ADDENDUM NO. 2
HGTC CONSTRUCTION OF
GT WORKFORCE TRAINING CENTER
GEORGETOWN, SOUTH CAROLINA
STATE PROJECT NUMBER H59-6255-CB
PMH | CROFT PROJECT NO. 23041
September 15, 2025

THIS ADDENDUM CONTAINS:

- TWELVE (12) PAGES OF WRITTEN ADDENDUM
- FORTY-SIX (46) PAGES OF SPECIFICATIONS
- THREE (3) PAGE OF BULLETIN DRAWINGS
- TWELVE (12) FULL SIZE DRAWINGS

1 FIRST FLOOR POWER & TELECOM PLAN A
E101 SCALE: 1/8" = 1'-0"

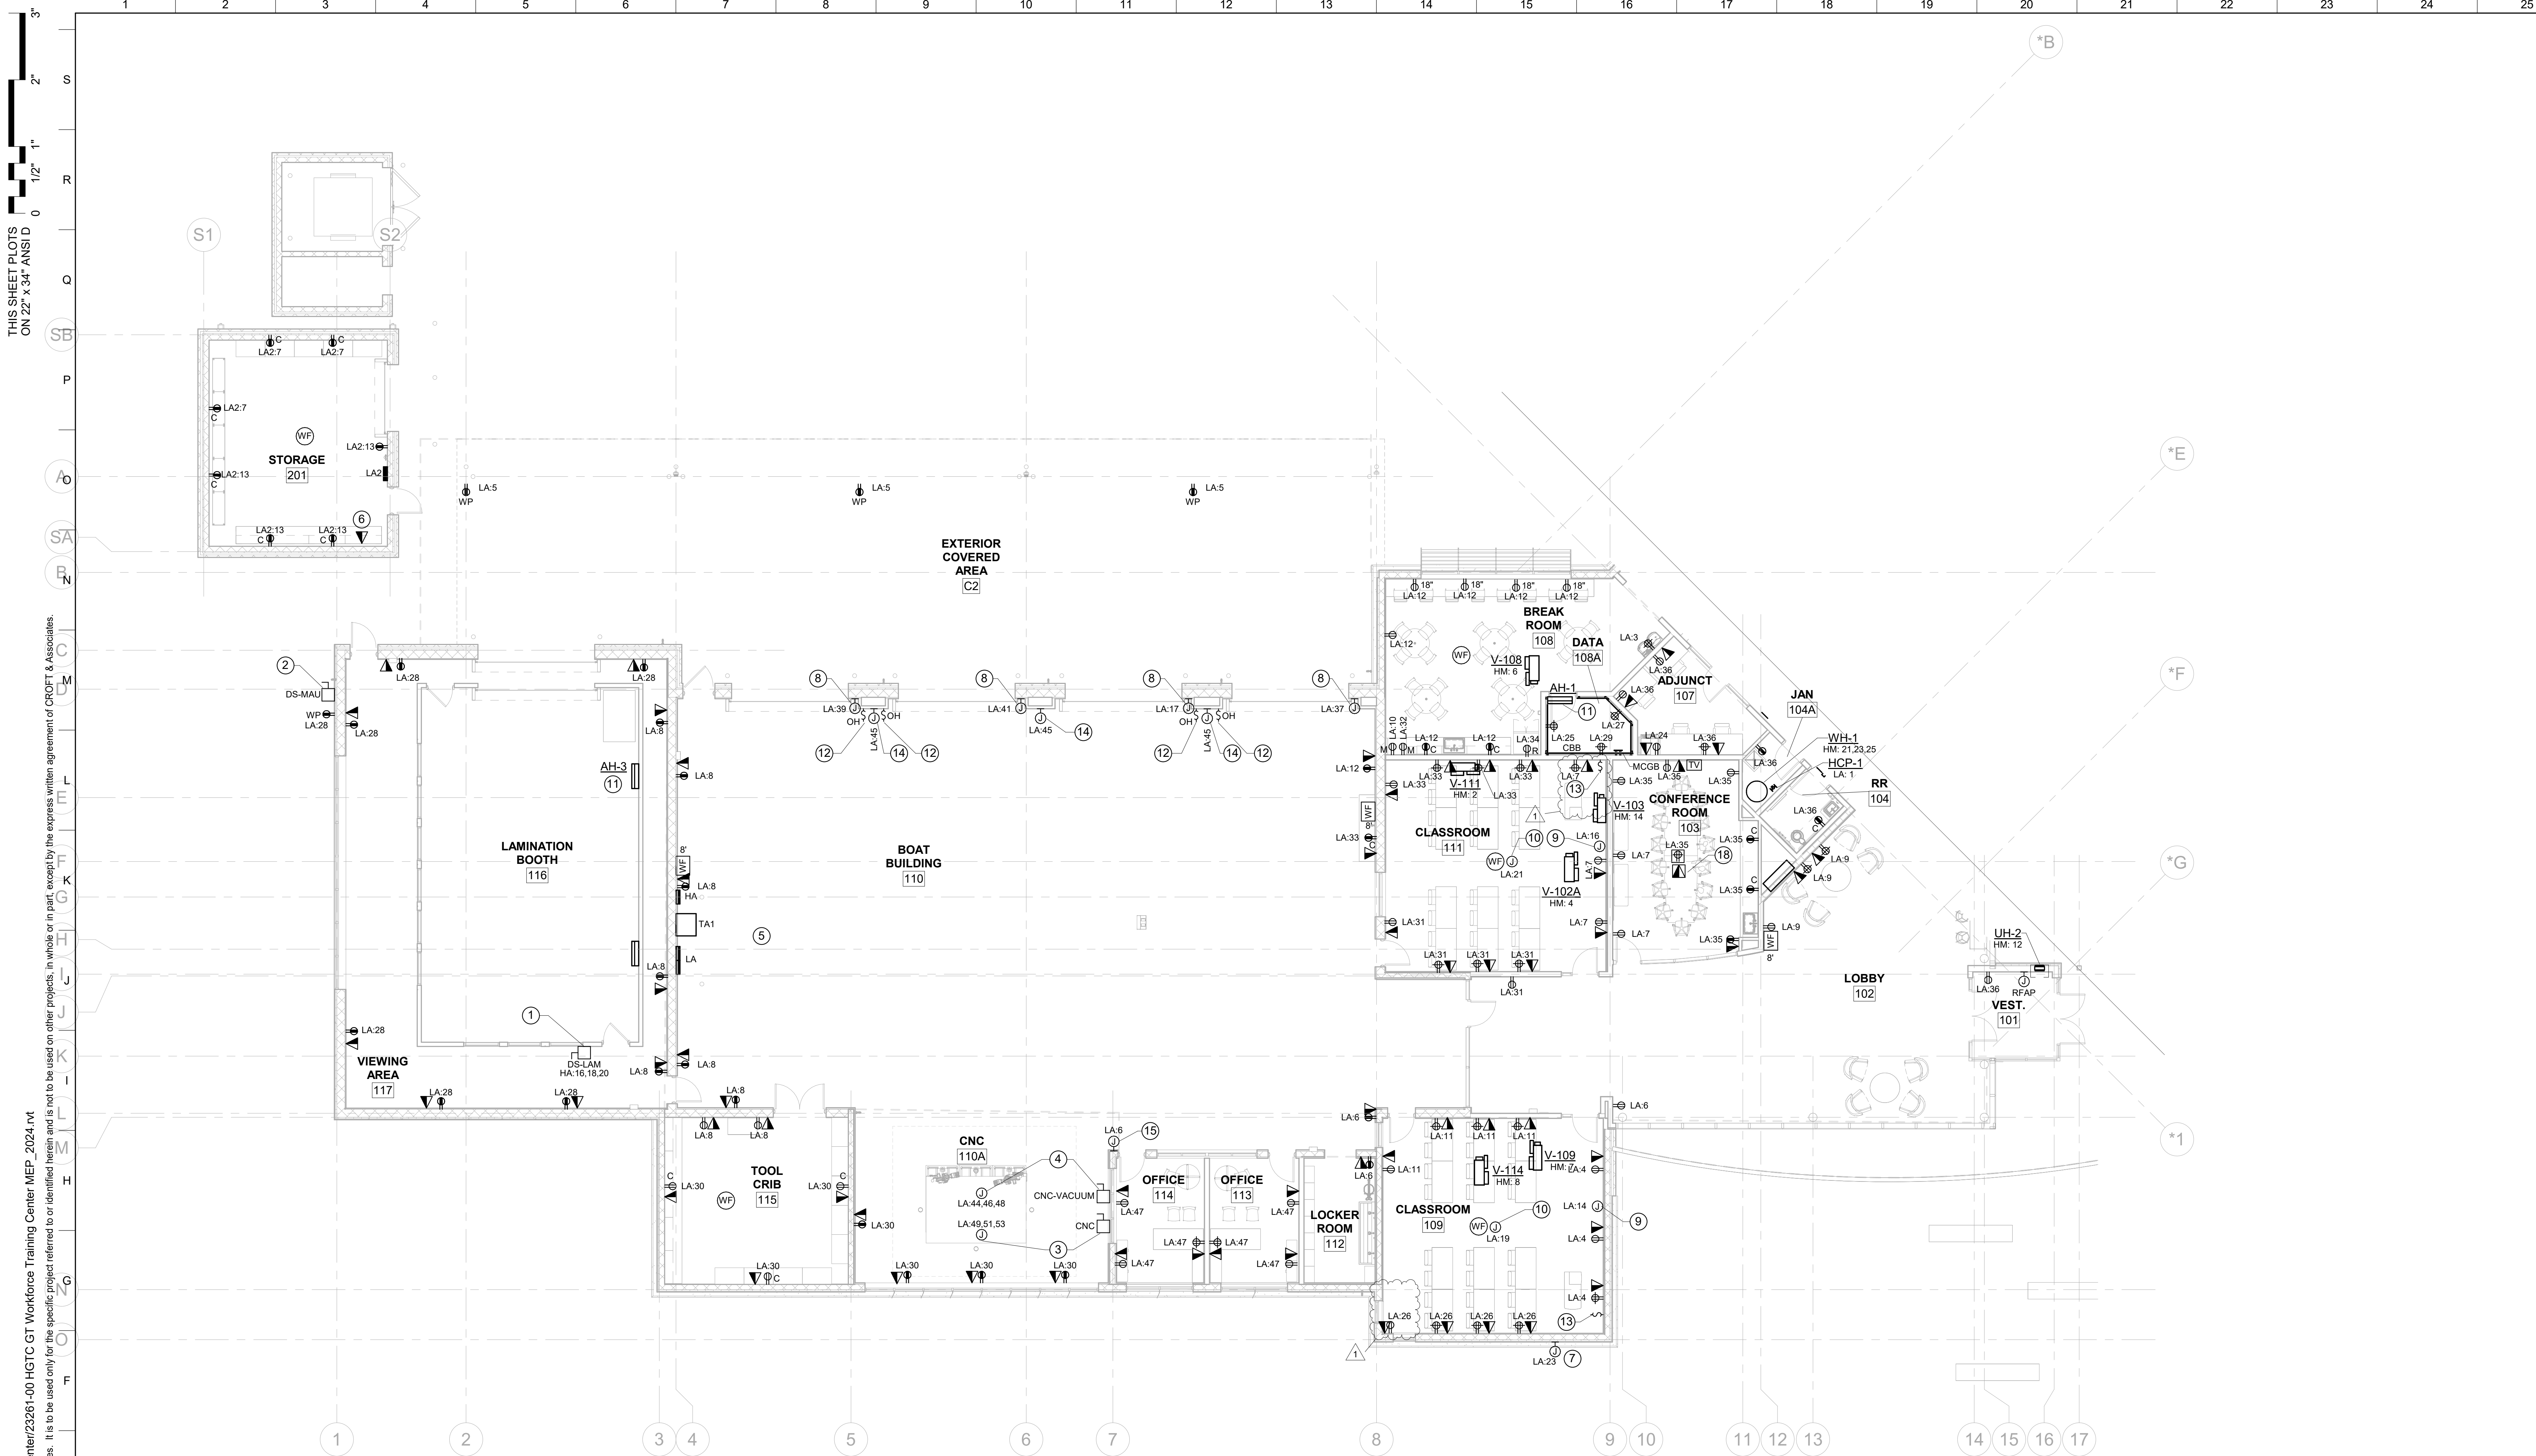
Q10. SHEET E101-----WHERE IS THE NOTE NARRATIVE FOR NOTE 18 (FLOOR BOX IN ROOM #103).

Q11. SHEET E101 & E102 WHAT SIZE CONDUIT STUB UPS ARE REQUIRED FOR TELECOM/DATA OUTLETS.

A10. *Keynote 18 located in the conference room should be keynote 15, which calls for 2" conduit to be routed from the floor box to the TV rough-in location.*

A11. *Provide 1" Conduit with pull wire for Telecom/Data outlets above the lay-in ceiling. Turn conduit 12" into ceiling cavity a minimum of 6" above the ceiling and terminate with an insulated bushing.*

- A. Contractor's attention is directed to SHEET E101 – FIRST FLOOR POWER & TELECOM PLAN A. Contractor is advised to omit this sheet in its entirety and replace with SHEET E101 – FIRST FLOOR POWER & TELECOM PLAN A (attached herewith) dated 9/9/25 and consisting of 1 page for the Receptacle and Data moved in Classroom 109 and Classroom 111.

1 FIRST FLOOR SYSTEMS PLAN A
E301 SCALE: 1/8" = 1'-0"

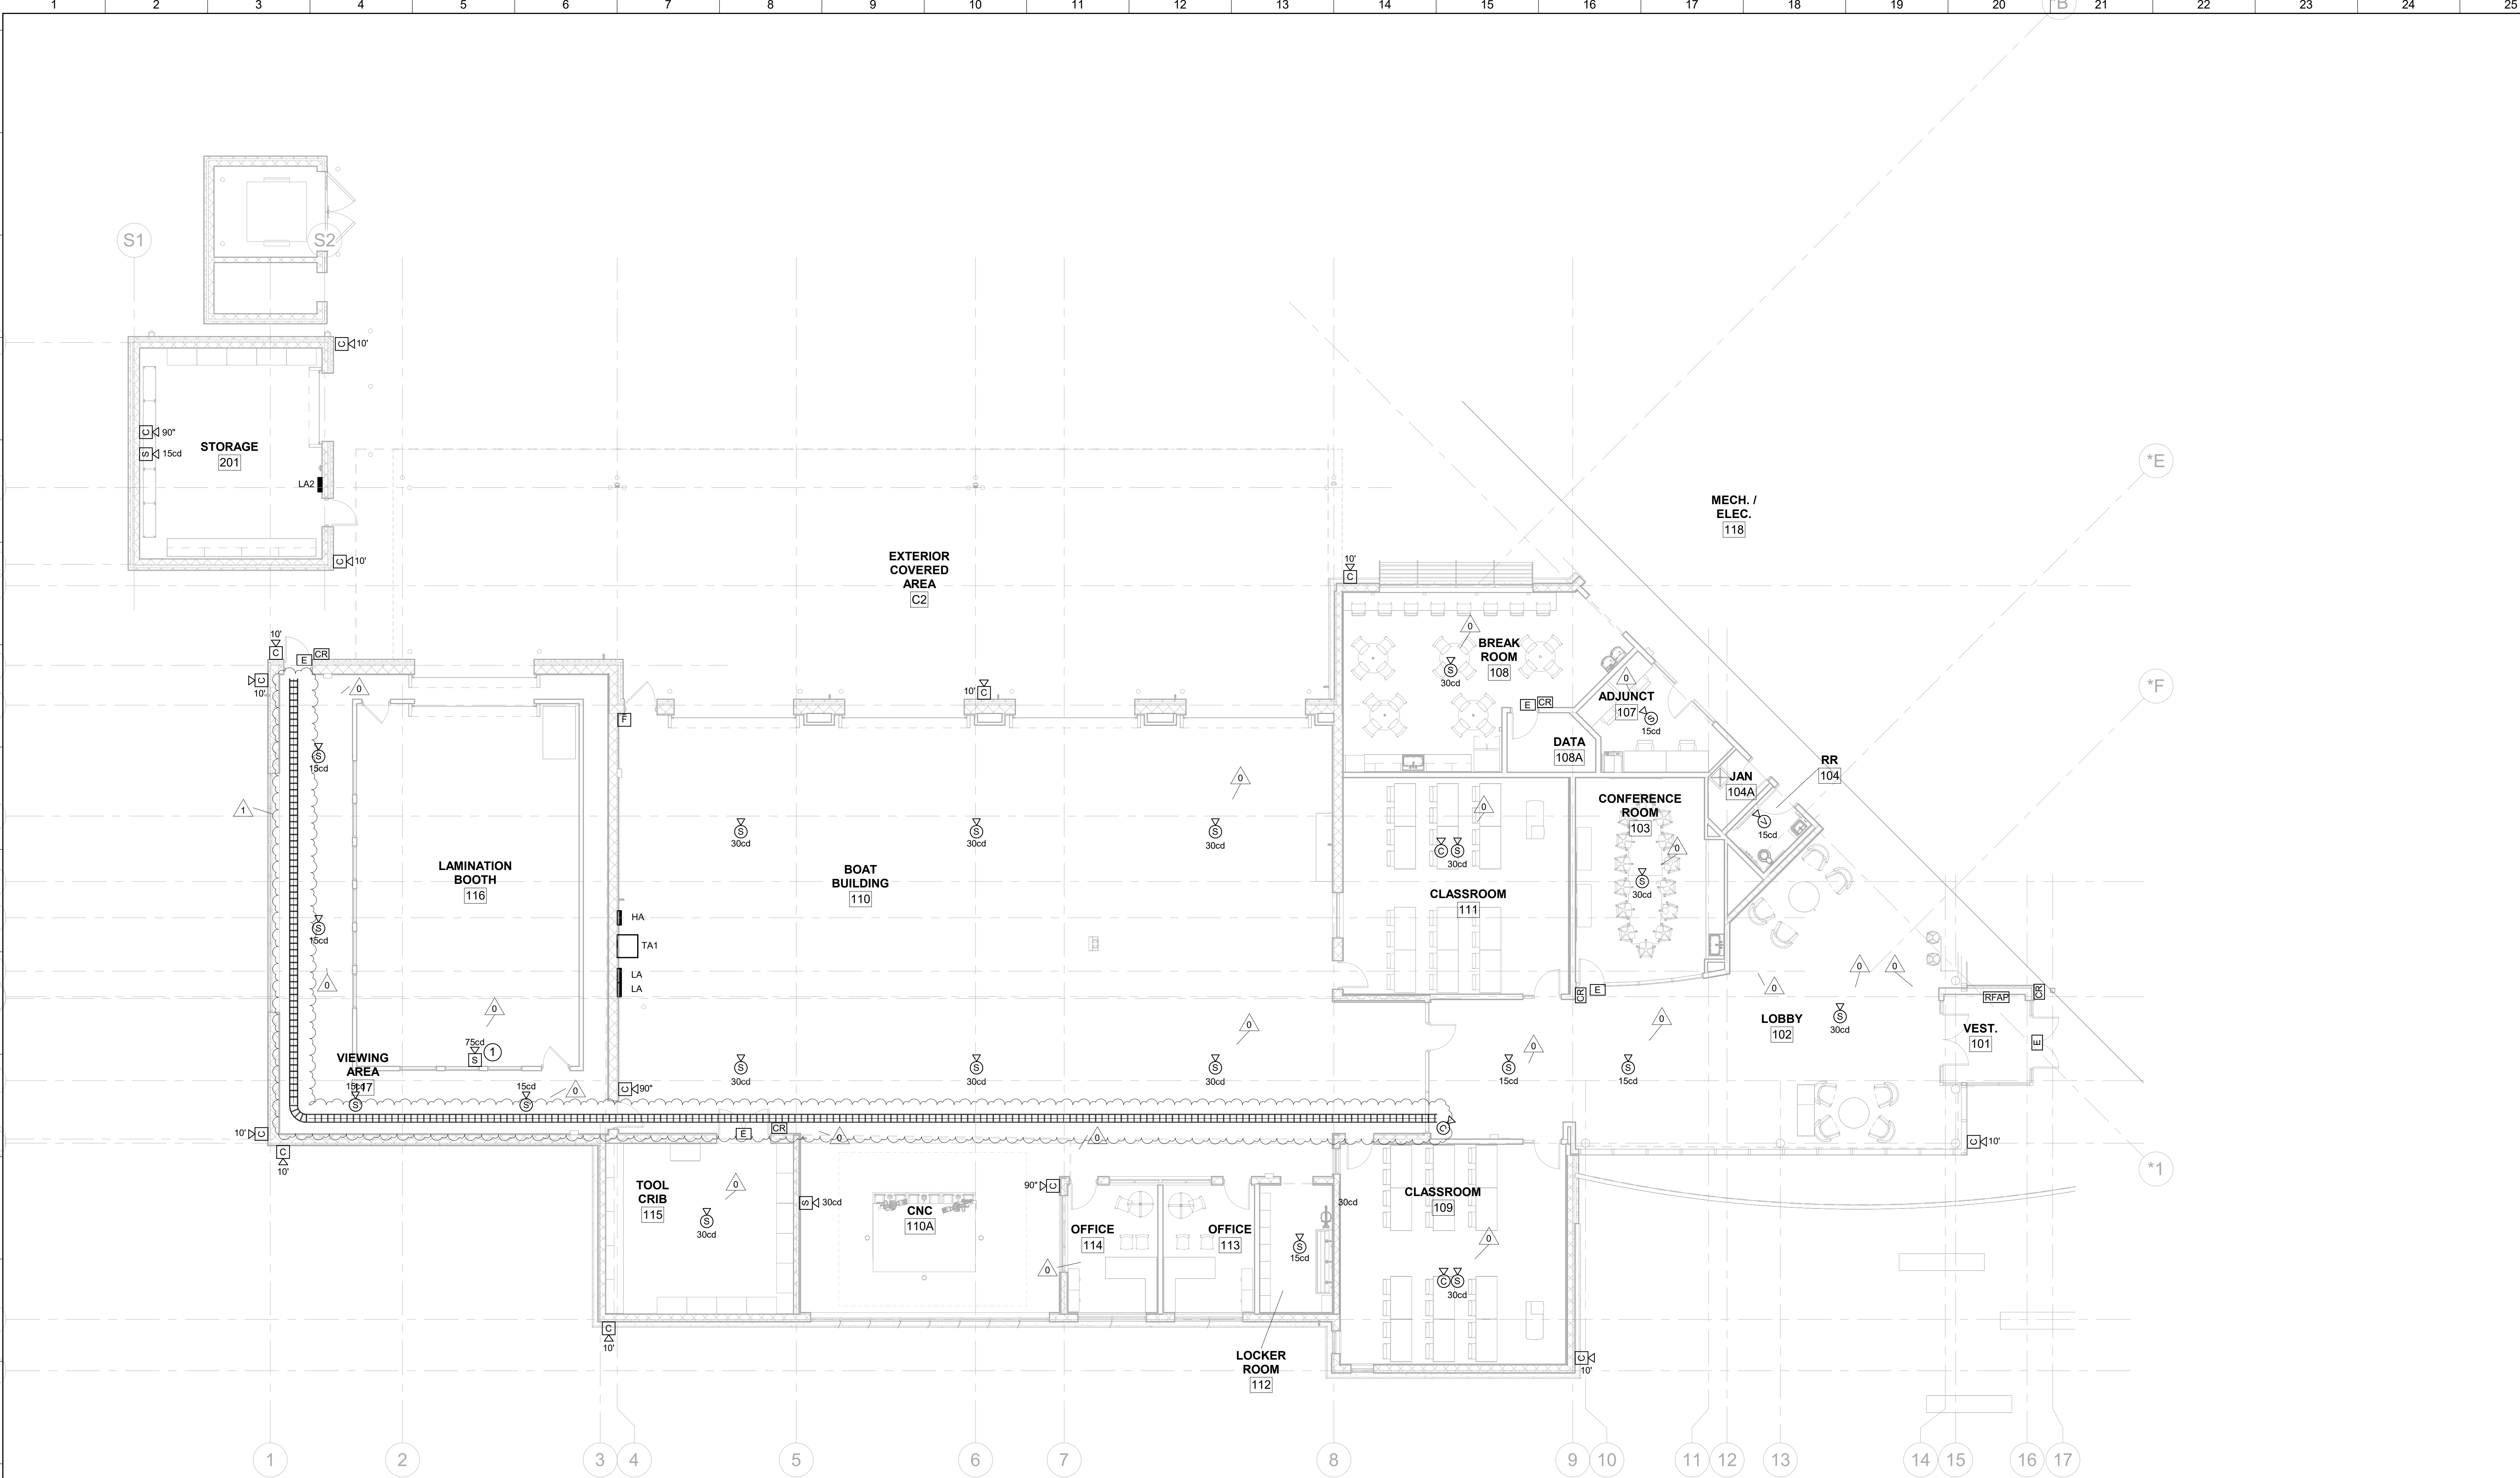
Q16. SHEET E301---WHAT ARE THE CONDUIT REQUIREMENTS FOR THE CARD READERS AND THE ELECTRONIC DOOR STRIKES.

Q17. SHEET E301—WHAT ARE THE CONDUIT REQUIREMENTS FOR THE SECURITY CAMERAS.

A16. *Provide 1" Conduit for Card Readers and Electronic Door Strikes. Type of conduit shall be indicated in specs.*

A17. *Provide 1" Conduit for Security Cameras. Type of conduit shall be indicated in specs.*

- A. Contractor's attention is directed to SHEET E301 – FIRST FLOOR SYSTEMS PLAN A. Contractor is advised to omit this sheet in its entirety and replace SHEET E301 – FIRST FLOOR SYSTEMS PLAN A (attached herewith) dated 9/9/25 and consisting of 1 page for the addition of a cable tray route and a General Note to coordinate cable tray routing with crane rail locations added.
